ALERT SERVICE BULLETIN

505-22-32

MODEL AFFECTED: 505

SUBJECT: ELECTRICAL HARNESSSES, INSPECTION OF.

Figure 1 – Helicopter Station Locations

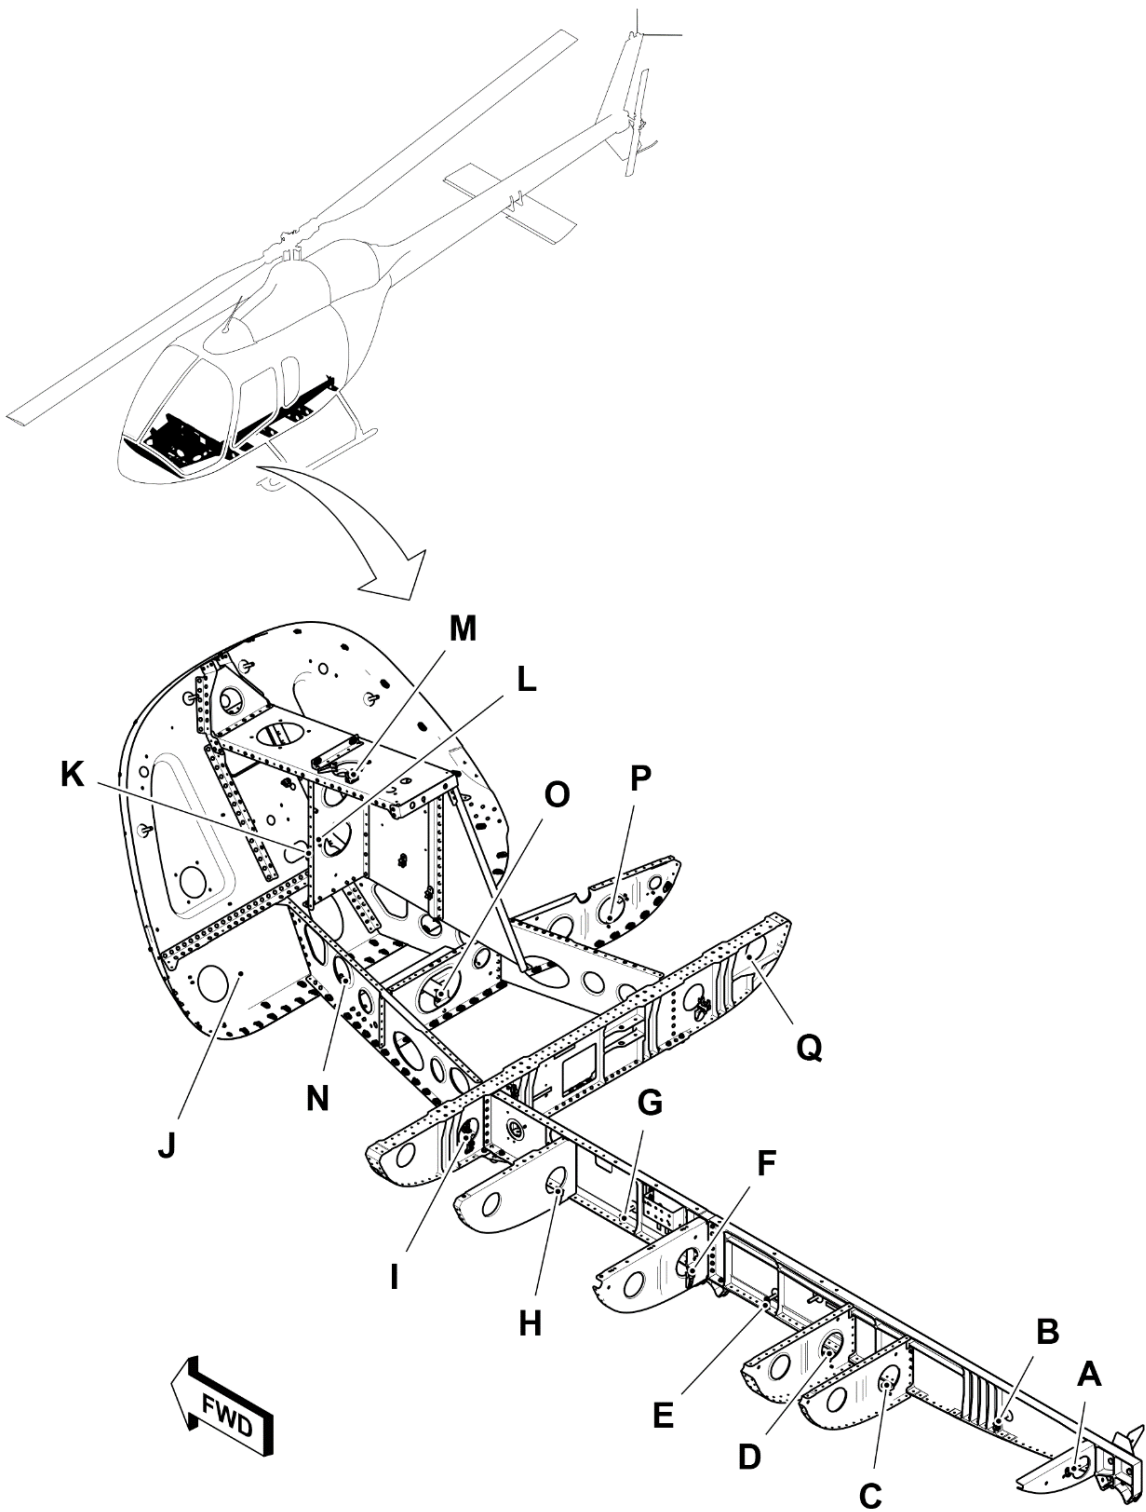
3. Do a detailed visual inspection of the wire harnesses at the following clamping/attachment locations (FS = Fuselage Stations, BL= Buttock Line).

Refer to **Figure 1** for locations.

- A. BL-12, FS180
- B. BL-12, between FS155 and FS180
- C. BL-12, FS155
- D. BL-12, FS146
- E. BL-12, between FS127 and FS146
- F. BL-12, FS127
- G. BL-12, between FS109 and FS127
- H. BL-12, FS109
- I. BL-12, FS98

- J. BL-12, FS65. (Canted Bulkhead)
- K. BL0, FS65. (Canted Bulkhead)

- L. BL0, FS67
- M. BL-2, FS70 top of pedestal
- N. BL0, FS82 FWD Keel Beam
- O. BL0, FS80 below pedestal

- P. BL22, FS82
- Q. BL24, FS98

Wire bundles should have a minimum clearance of 0.375 Inches (9.53 mm) from tubing/structure.

4. Repair damaged wires/bundles and identify/address the source of the chafing. Refer to Chafing Control Guide (CSSD-PSE-90-001) and Electrical Standard Practice Manual (BHT-ELEC-SPM).
 - a. If the fouling condition cannot be rectified using the information within these manuals, contact Bell Product Support Engineering at productsupport@bellflight.com with the following information:
 - (1) Include the helicopter serial number in the subject line of the email.
 - (2) Include the ASB number 505-22-32 in the subject line of the email.
